From: Keith Leitch [mailto:keith@leitch.tv]
Sent: Tuesday, September 15, 2009 11:51 AM
To: Mohammad Habib
Cc: John Fiori
Subject: Amendment to KTVJ-LP STA (BSTA - 20090914AAZ)

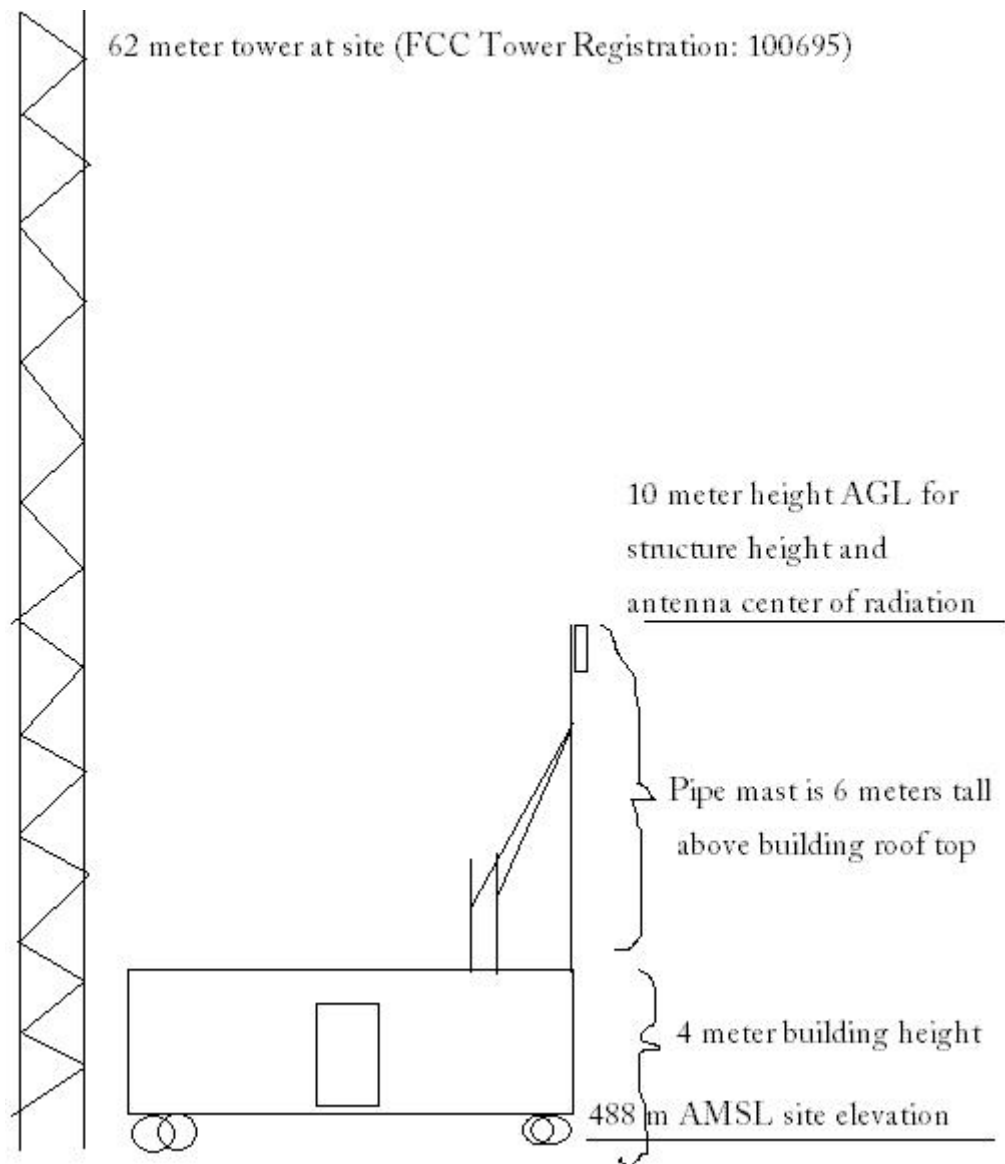
Thank you for your help. I would like to amend the STA that was filed for KTVJ-LP (BSTA - 20090914AAZ). Specifically, the antenna location site elevation above mean sea level should be 488 meters. Also, the applicant will be using a pipe mast on the building. The height of the top of the mast AGL is 10 meters (4 meter building height plus 6 meter pipe height). The height of radiation center above ground is also 10 meters. No antenna structure registration is needed due to the pipe being below the minimum required for FAA and FCC registration. Please find attached a diagram of the antenna structure and antenna. I have also included the diagram below.
